#### APPEAL SUMMARY

<b>Appeal ID:</b> 24364	<b>Project Address:</b> 2211 SW 4th Ave
<b>Hearing Date:</b> 11/25/20	<b>Appellant Name:</b> Joshua Scott
<b>Case No.:</b> B-003	<b>Appellant Phone:</b> (206) 755-1290
<b>Appeal Type:</b> Building	<b>Plans Examiner/Inspector:</b> Gail Knoll
<b>Project Type:</b> commercial	<b>Stories:</b> 6 <b>Occupancy:</b> R-2 <b>Construction Type:</b> III-A over 1-A
<b>Building/Business Name:</b>	<b>Fire Sprinklers:</b> Yes -
<b>Appeal Involves:</b> Correction of a violation	<b>LUR or Permit Application No.:</b>
<b>Plan Submitted Option:</b> pdf [File 1] [File 2] [File 3]	<b>Proposed use:</b> Multi-family Residential

##### Appeal item 1

Project: GRANT AND 4TH  
Date: 09/23/20  
Name: CHASE AND SOFFIT ADDITIONS IN STAIRWAY

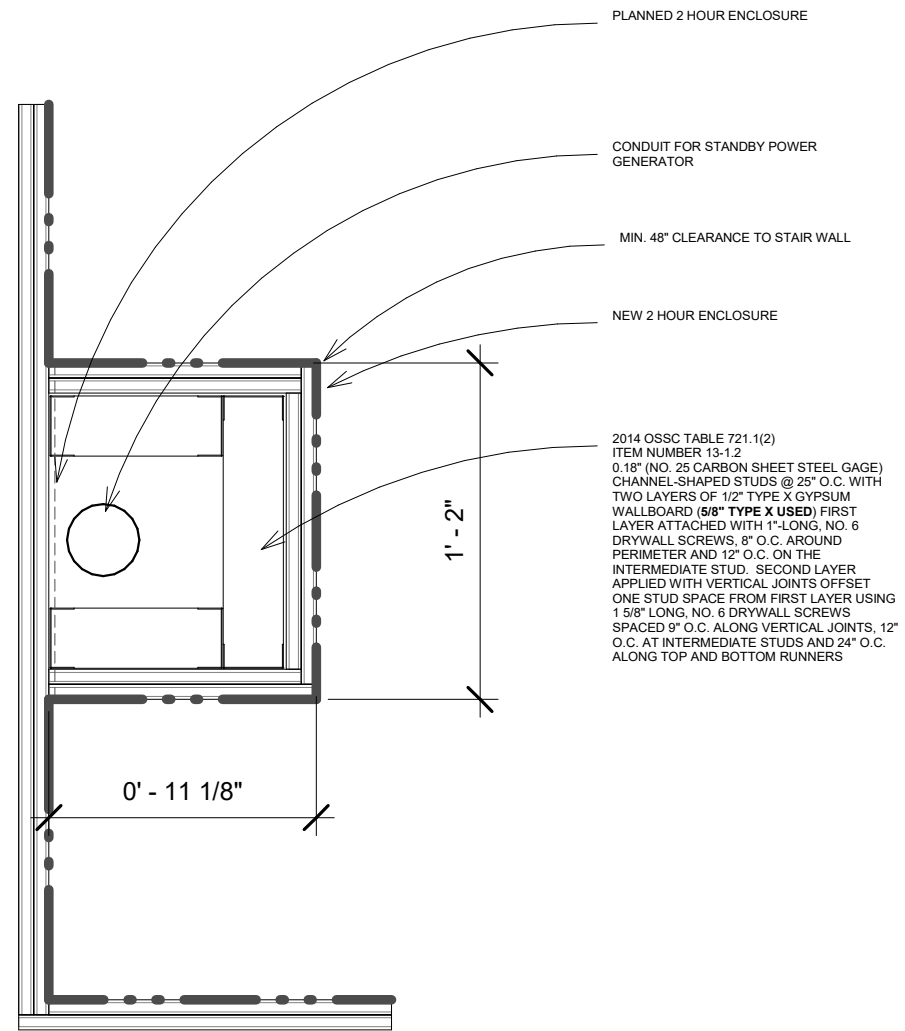
<b>Proposed Design</b>	The "penetrations" have been wrapped in a code provided 2 hour assembly, therefore, the actual membrane of the exit stair has been extended around the piping and conduit. This eliminates the penetration prohibited by 1022.5 and provides for a compliant condition.
<b>Reason for alternative</b>	There are 2 conditions that have been constructed differently than planned.  Water service piping was run across the 2nd floor exit stair ceiling instead of across the 3rd floor corridor as specified in the original plans. This was a construction error. The piping was already in place at the time of discovery. The appeal requested is to formally acknowledge a change in the extents of the 2 hour construction required for the interior exit stair. As constructed, equivalent life safety as had the "penetration" not been made has been provided.

Emergency generator power conduit was missed within the 2 hour construction the interior exit stair. This was a construction error The conduit was installed, exposed, in the interior exit stair. This penetration is not allowed. A 2 hour rated surround was added around the conduit, floor to ceiling, to eliminate the penetration.

Description: TO AVOID DISALLOWED PENETRATIONS THROUGH THE WALLS AND CEILINGS OF THE ENCLOSURE FOR THE STAIRWAY, THE ENCLOSURE IS PROPOSED TO BE EXTENDED AROUND THE REQUIRED ITEMS THAT RUN THROUGH THE STAIRWAY. THE ENCLOSURE IS PRESERVED WITH PROTECTION AROUND WHAT WOULD HAVE BEEN PENETRATING OBJECTS BEING PROVIDED IN LINE WITH OSSC TABLE 721.1

**Two hour separation of pipe and conduit within 2 hour stair assembly: Hold for additional information. Appellant may contact John Butler (503 865-6427) or e-mail at [John.Butler@portlandoregon.gov](mailto:John.Butler@portlandoregon.gov) with questions.**

Name: TURNING IN EXIT STAIR

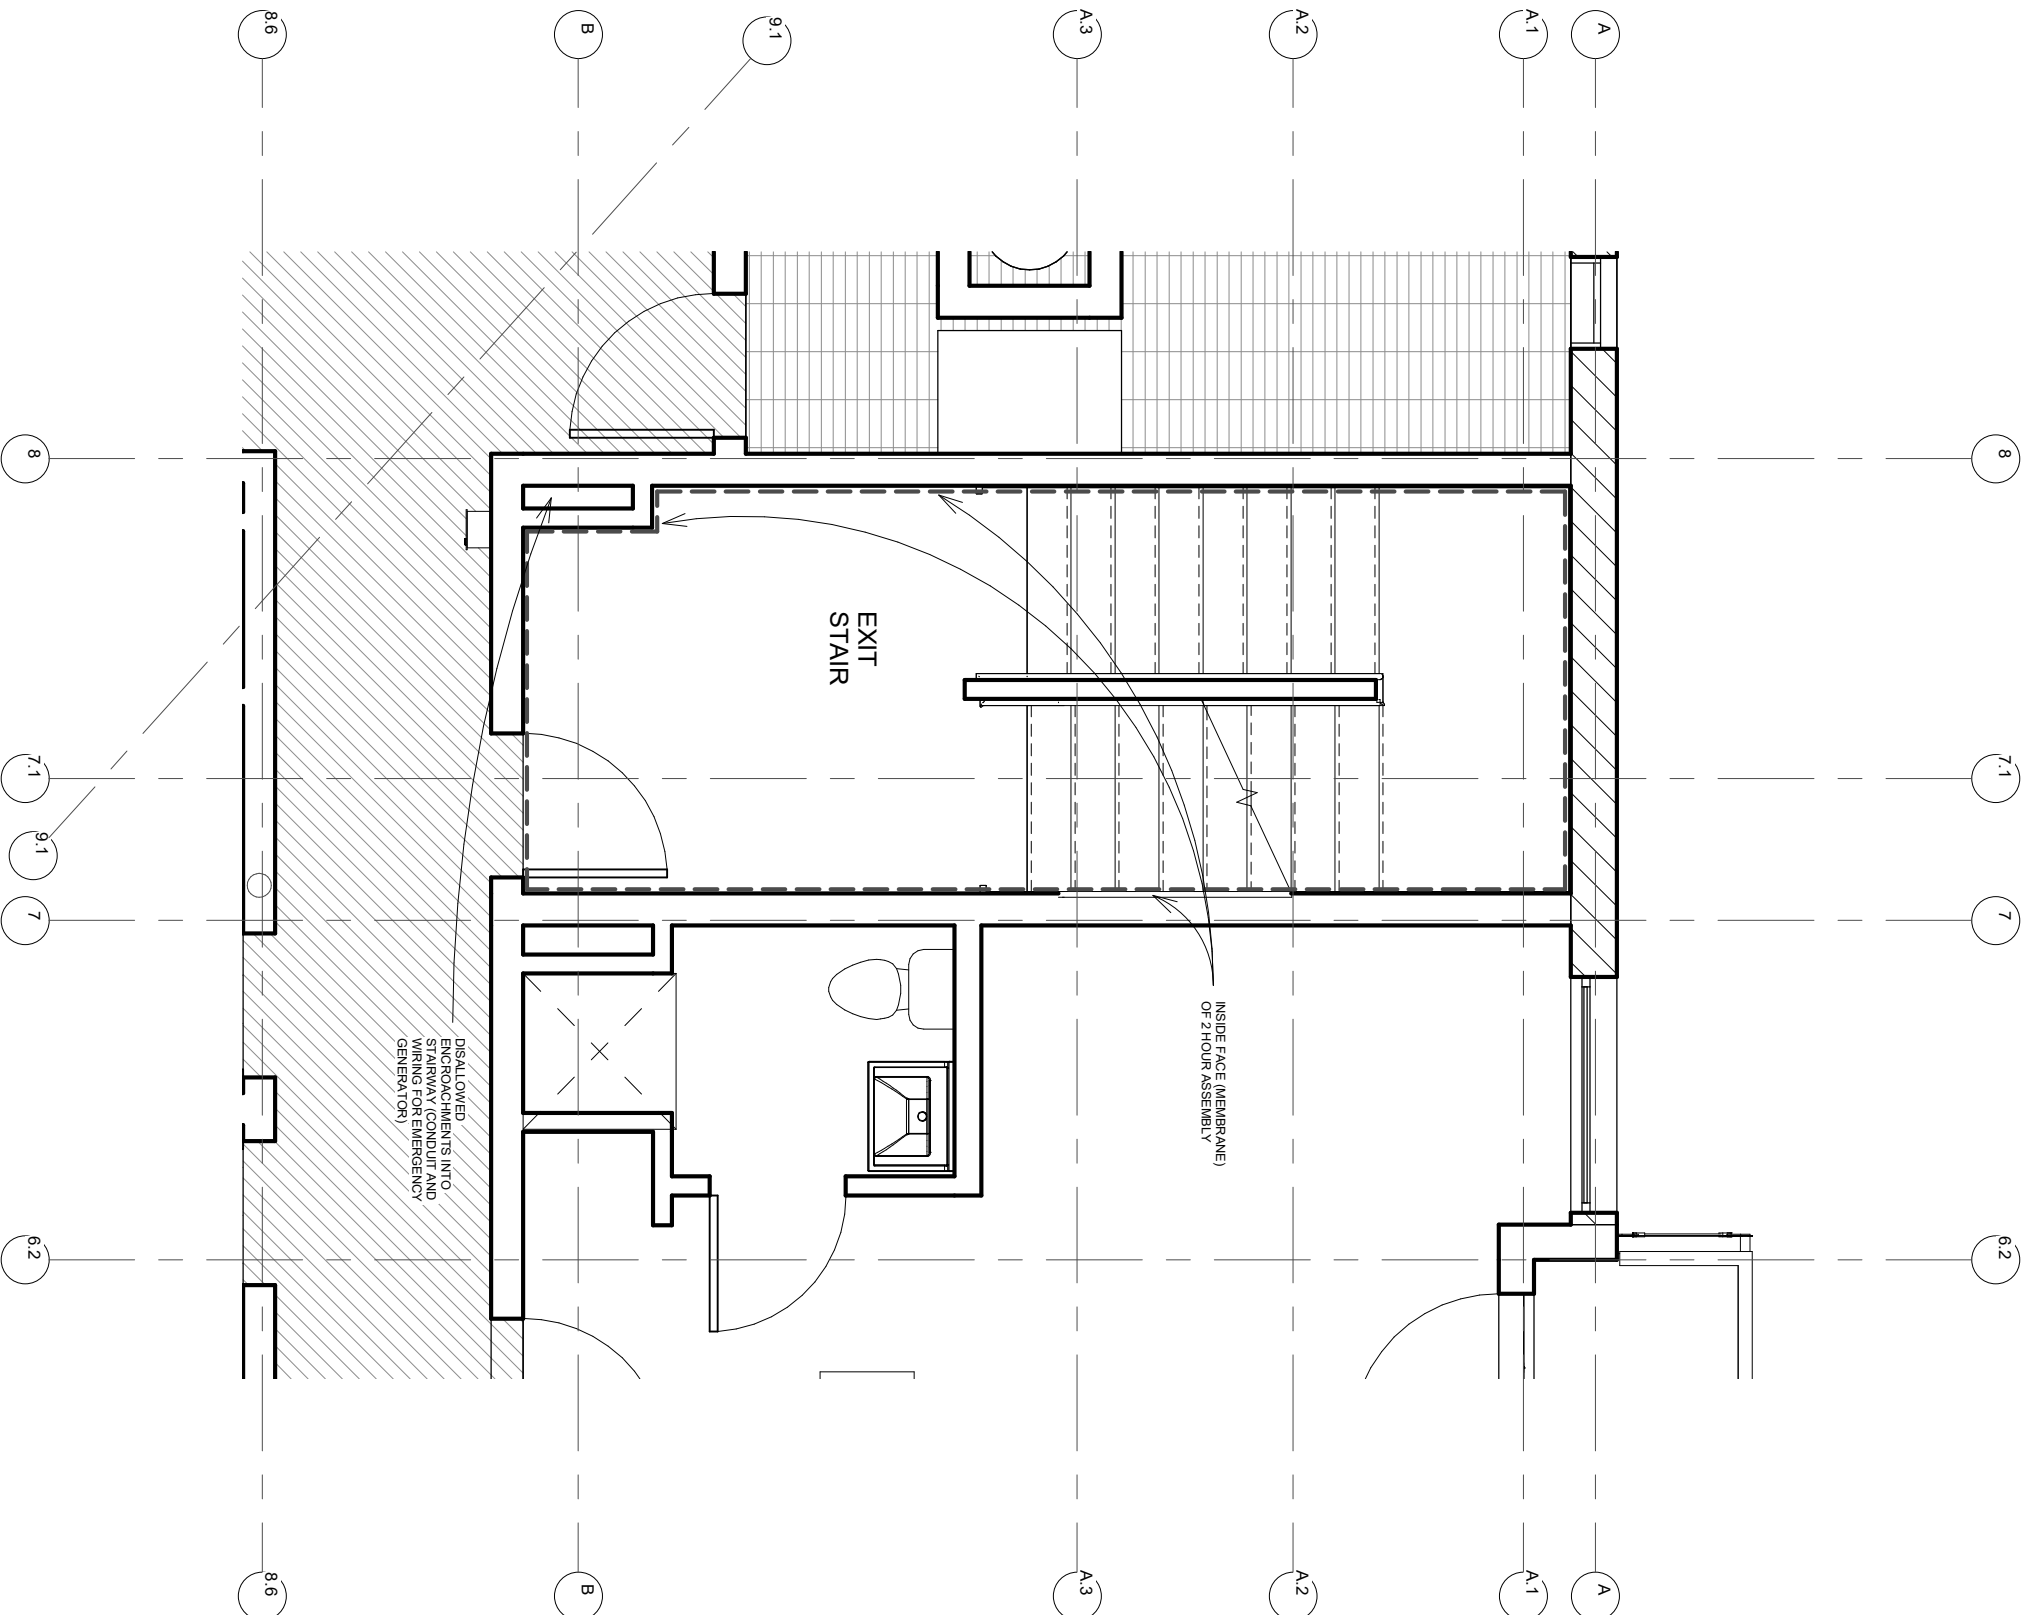
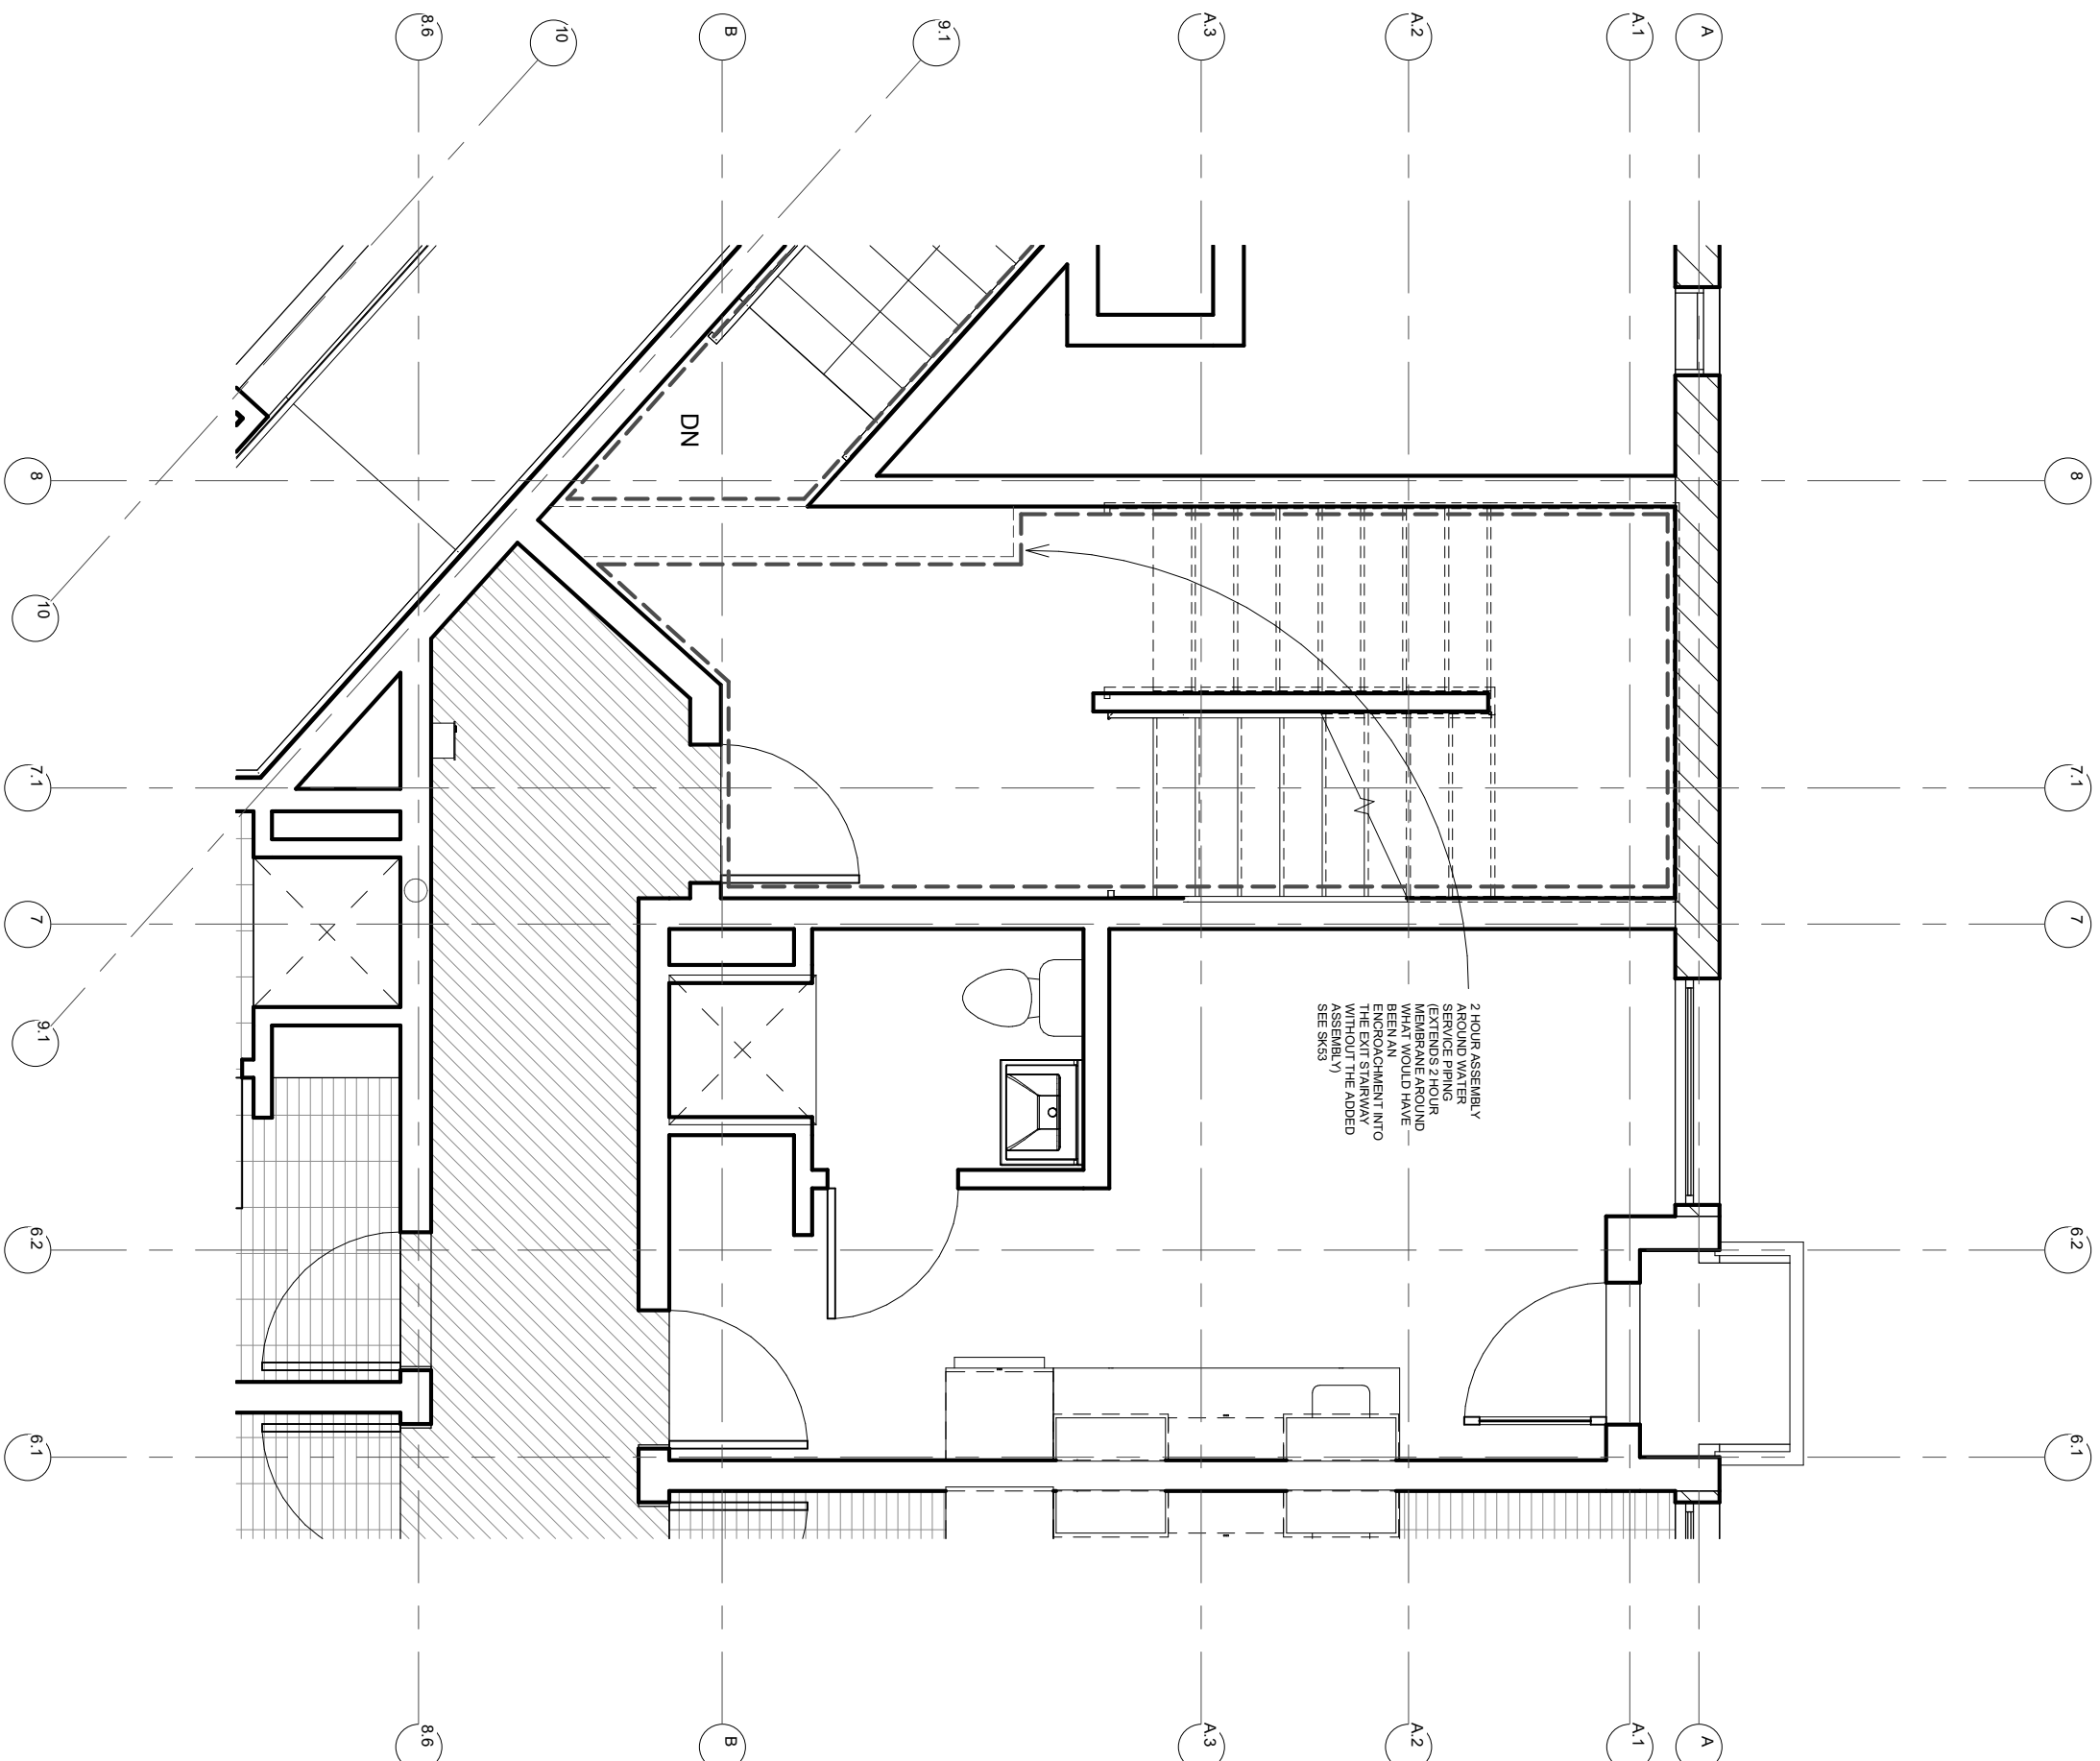
1  
SOFFIT AROUND PIPING IN STAIRWAY  
1/4" = 1'-0"
